SECTION 00 9112
ADDENDUM NUMBER 2

DATE: 03/02/2021
PROJECT: CITY OF MILLERSBURG FIRE STATION 15
ARCHITECT'S PROJECT NUMBER: 20006
OWNER: CITY OF MILLERSBURG
ARCHITECT: SODERSTROM ARCHITECTS

4 TYPICAL FLAG POLE DETAIL
1" = 1'-0"

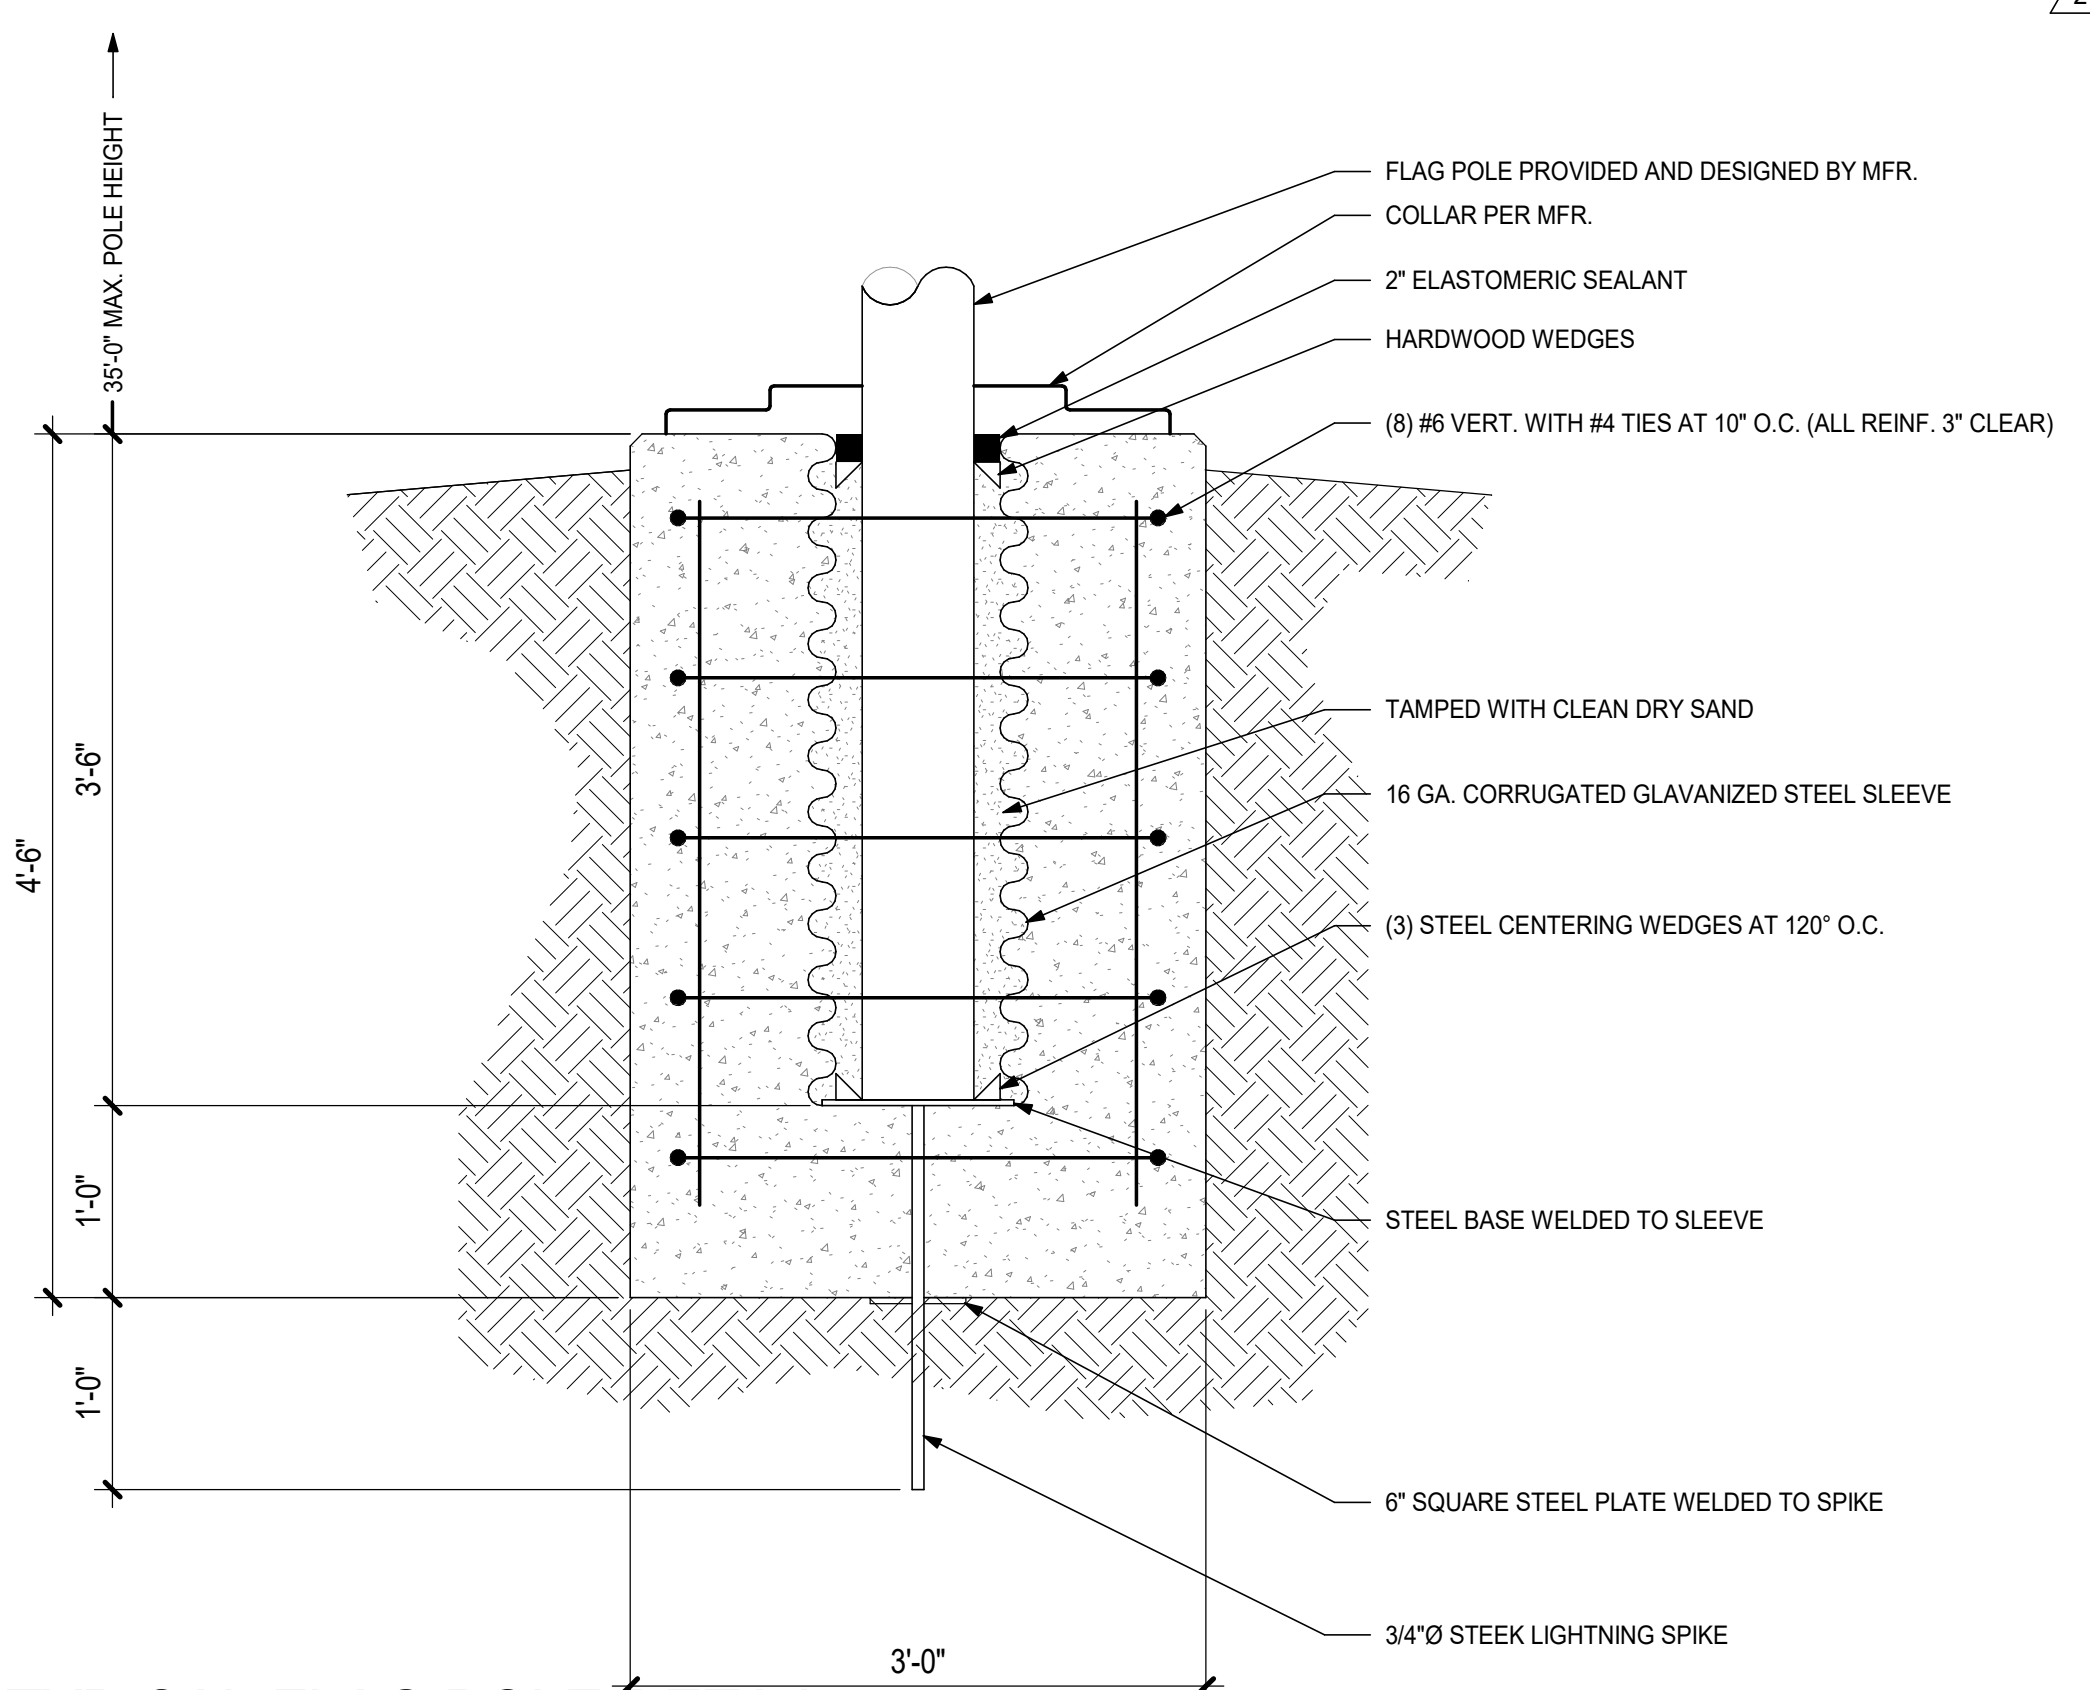
DRAWING S4.06

Added Detail 4 – Typical Flag Pole for flag pole foundation

- 63. Please provide concrete details/dimensions for flag pole bases.**
- A. See revised sheet S4.06 issued with this addendum.
- 64. The landscape drawings do not show any irrigation system and there is no irrigation spec section. However, 2/C3.00 indicates a future irrigation lateral per separate design build contract. Please confirm if an irrigation system is part of this project or not.**

2 NORTH ADA RAMP ENLARGEMENT
 1" = 5'

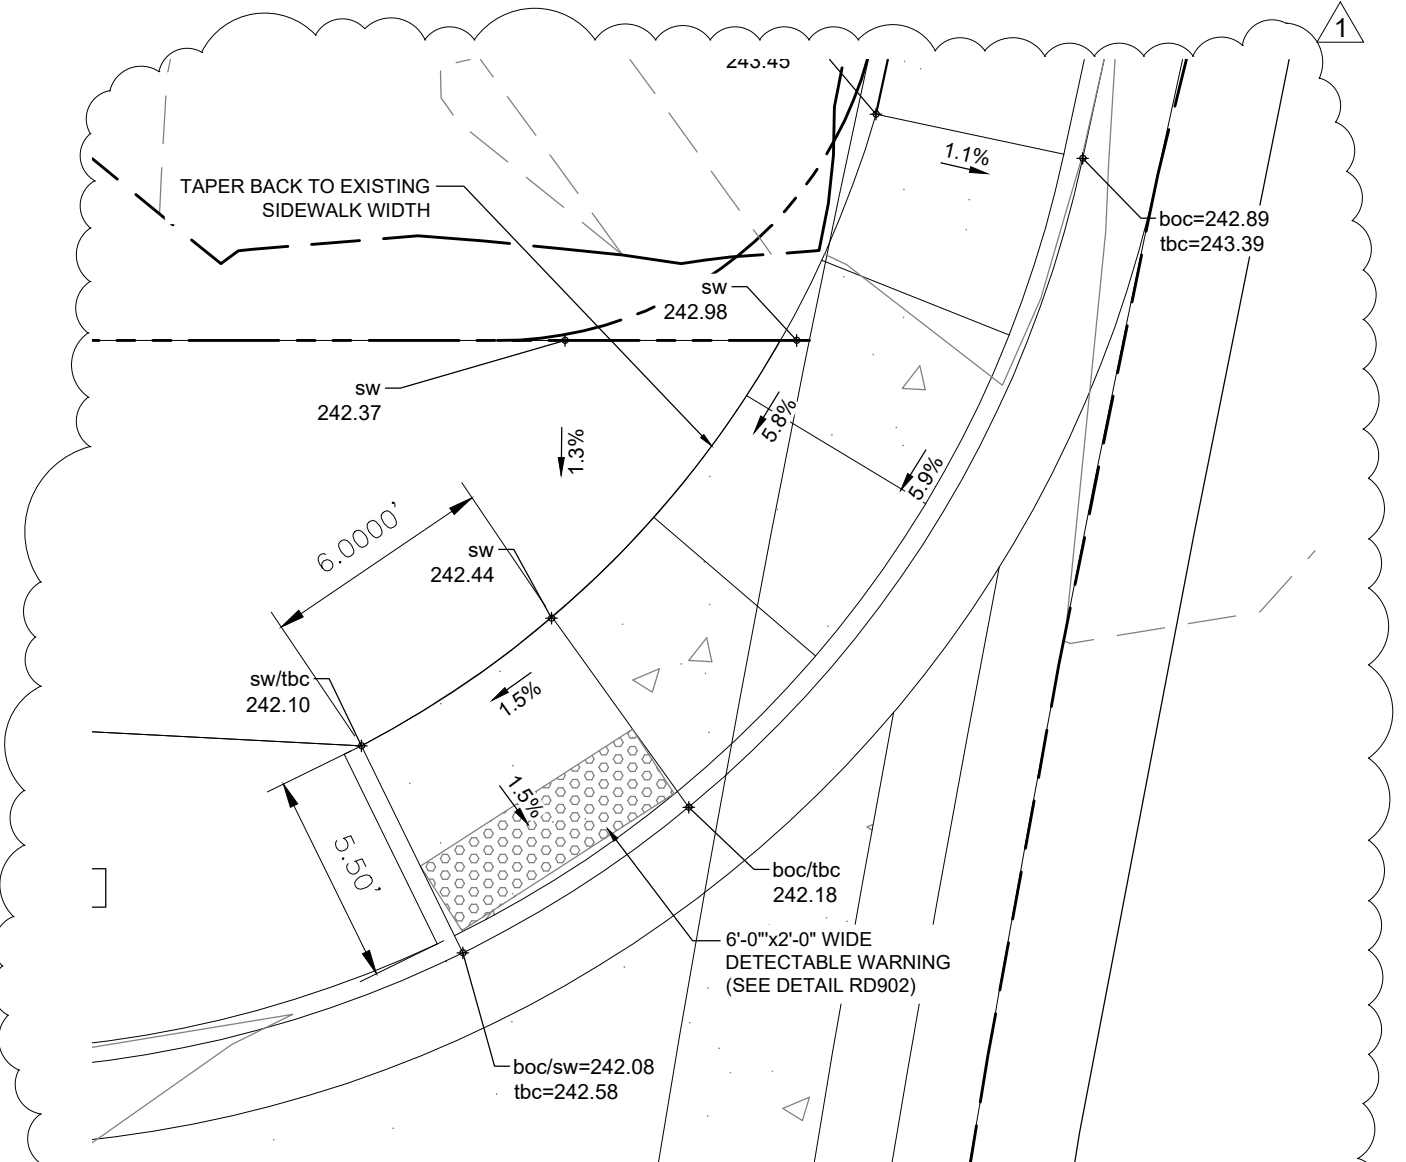
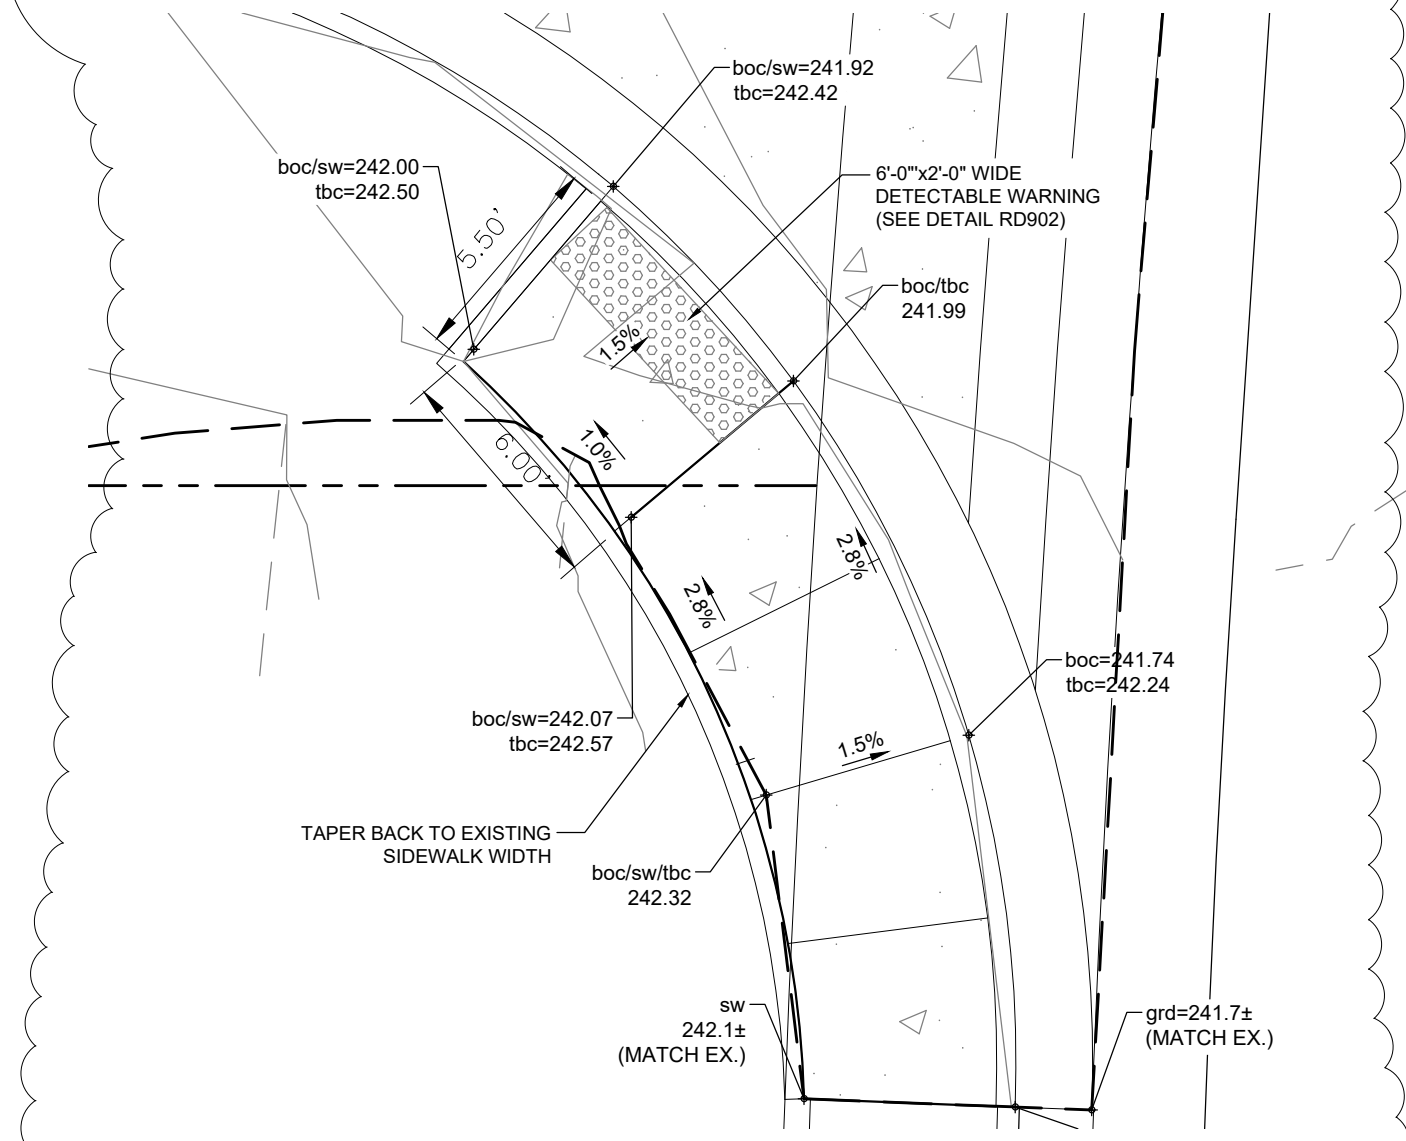
DRAWING C2.00

Revise Details 2 and 3 to match Linn County ADA ramp requirements

EL1.01

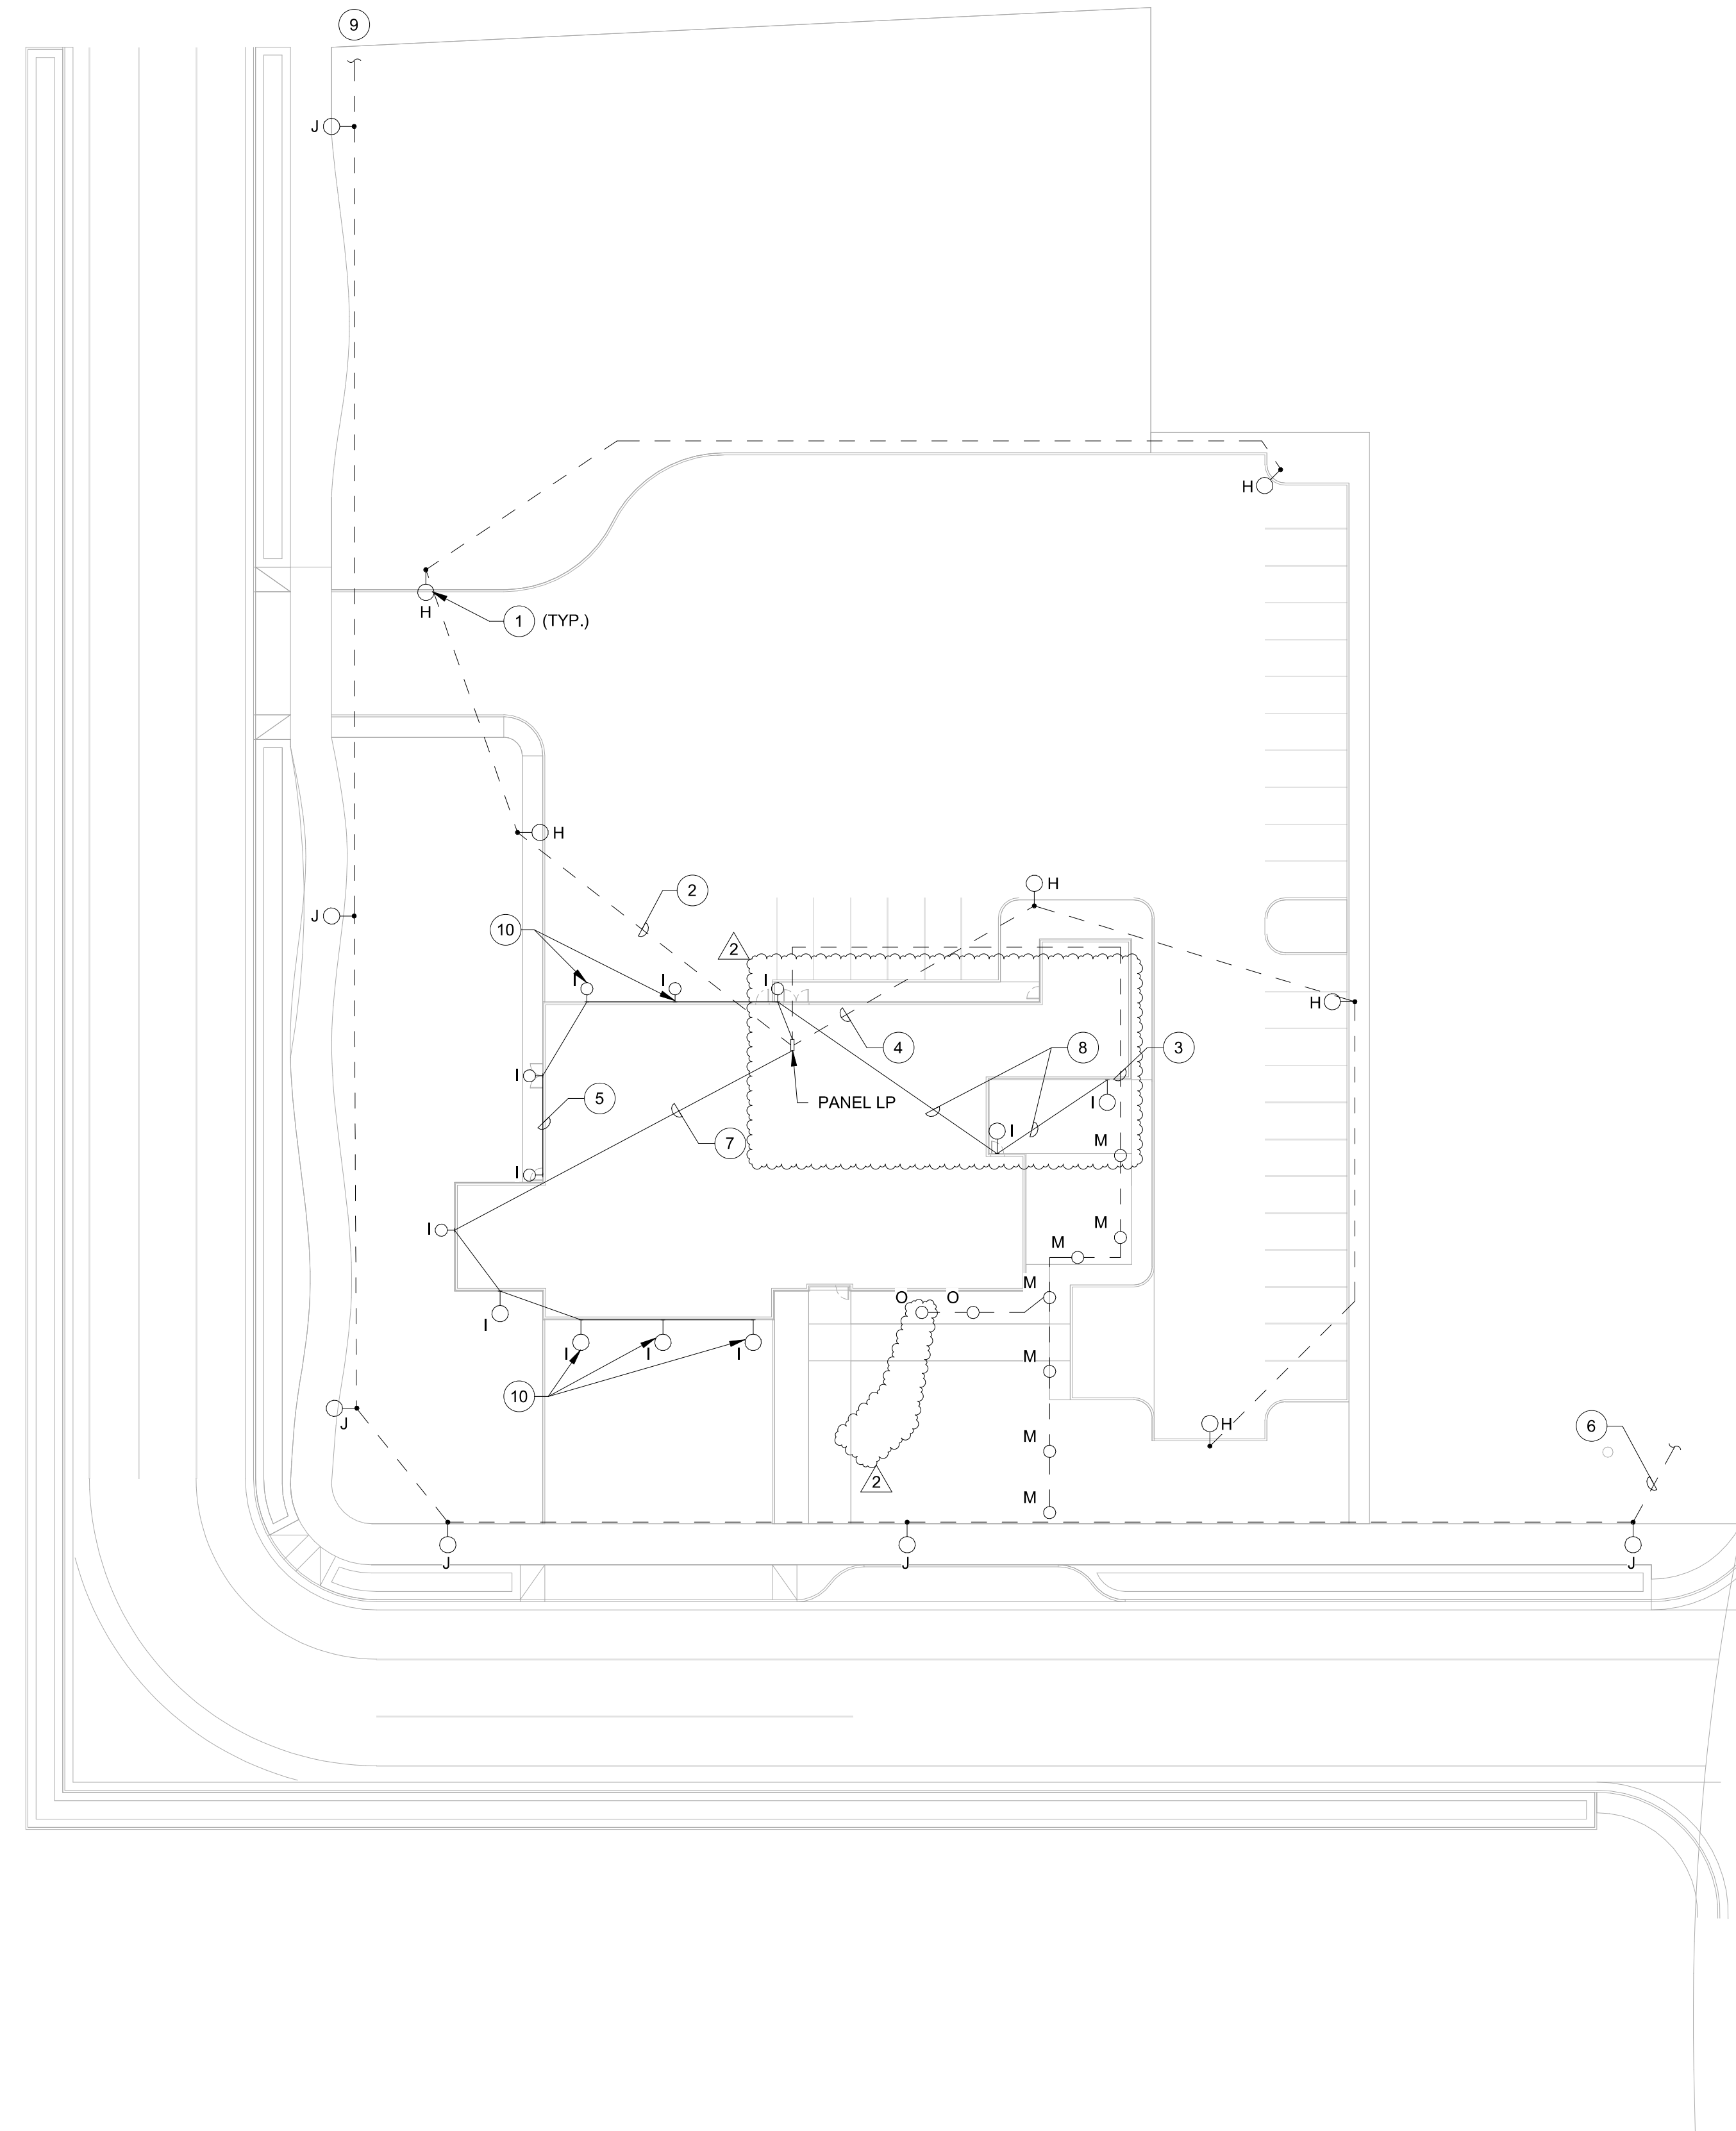
DRAWING EL1.01

Added fixtures I at Courtyard

Delete Fixture I at NE corner of building

Revise Keynote 6

Revise Lighting at south side of building
